CONSTRUCTION SUMMARY
EARLGLEN INVESTMENTS INC.

LOT NUMBER	PHASE	HOUSE TYPE	CLOSING DATE
097 BLOCK 016	1	THE KATHERINE(END)-ELEV C-3 BDRM-3 BATHS	04-Aug-26

* INTERIOR COLOUR SCHEME *

* CONDUIT ATTIC to BSMT *

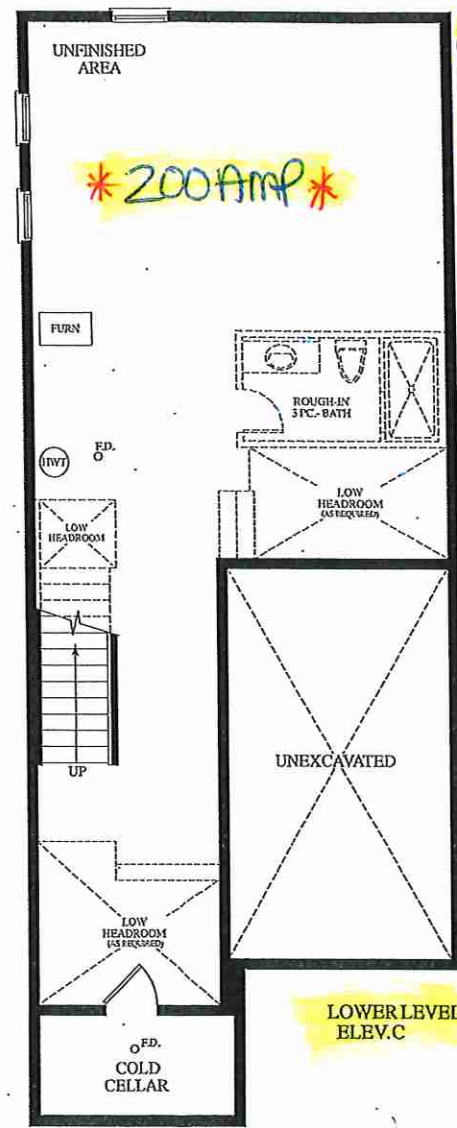
1 - ATTIC/BASEMENT-Install a conduit pipe from the attic to the basement (See Sketch)

(C) CABLE (X2)
(T) TELEPHONE (X2)

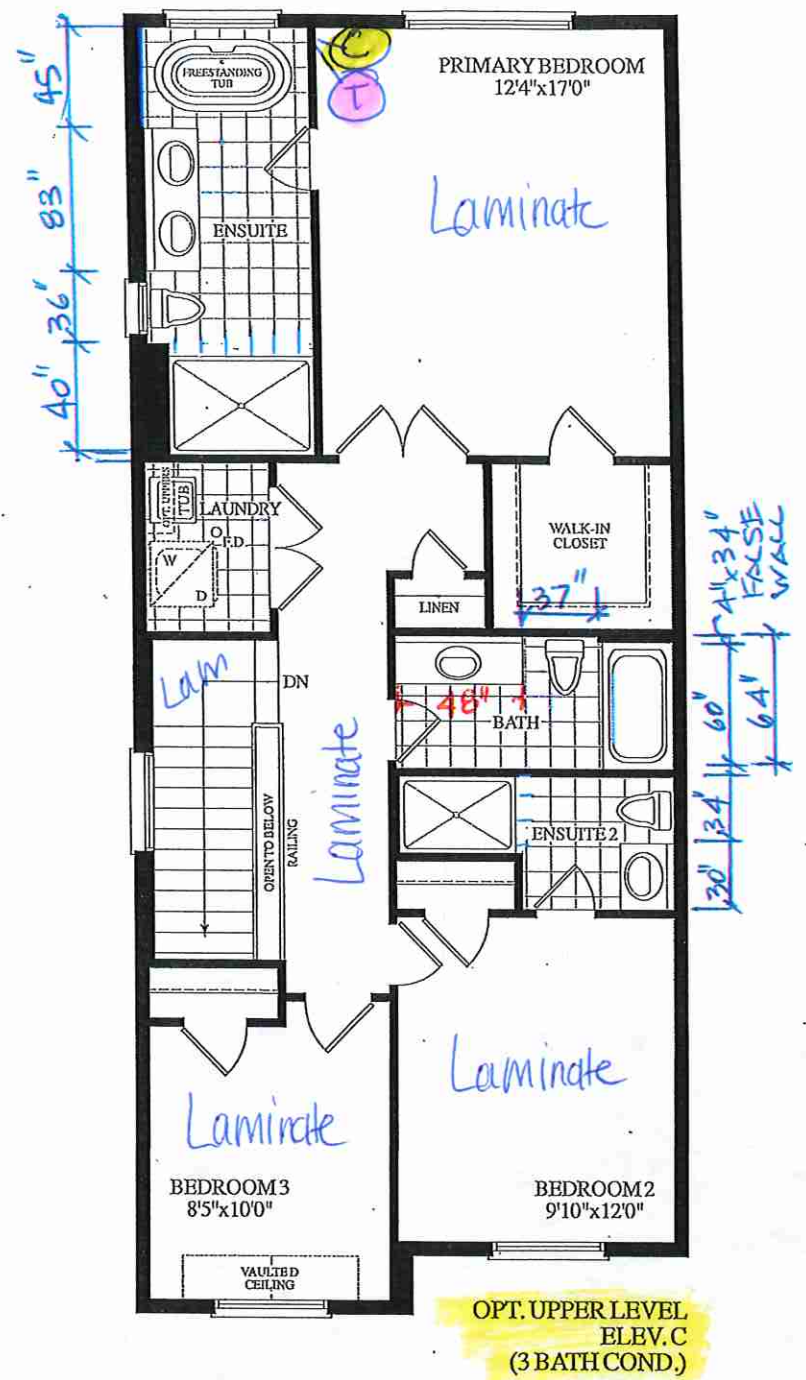
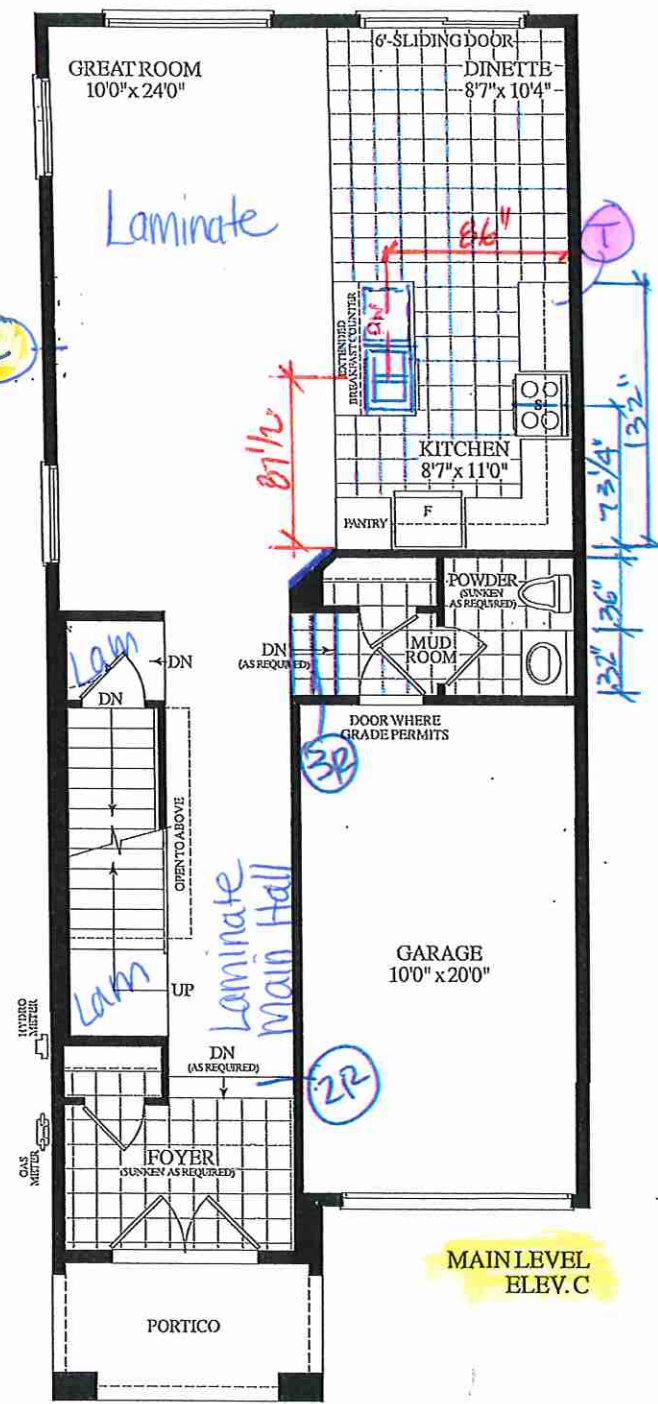
1 - Install standard Cable / Cat 6, Telephone (See Sketch) Note:
1 - GARAGE DOOR- Install the builders standard garage door handle with lock Note:
1 - APPLIANCE PACKAGE- Install the Standard Appliance Package throughout the home, where applicable. Note:
1 - KITCHEN & BATHROOMS - Purchaser has DECLINED All Upgrades offered during decor appointment at the decor centre for kitchen & bathroom cabinetry. Standard Kitchen Layout & Standard Bathroom Vanities to be installed as per standard plan. (See Sketch) Note:
1 - KITCHEN-Purchaser accepts and acknowledges that the builders standard fridge will be 30" wide. Note:
1 - KITCHEN-Install an upgraded "L" edge throughout the kitchen, where applicable Note:
1 - CLARIFICATION- KITCHEN/MASTER ENSUITE / ENSUITE #2/ MAIN BATH/ POWDER ROOM- Install the builders standard Plumbing Fixtures throughout all bathrooms AND Kitchen, where applicable. Note:
1 - SHOWER CEILINGS Purchasers have declined upgrade to install tiles on ceilings of shower stalls and Tub/Showers. Purchaser acknowledges there will be no tiles on ceilings of shower stalls and Tub/Showers Note:
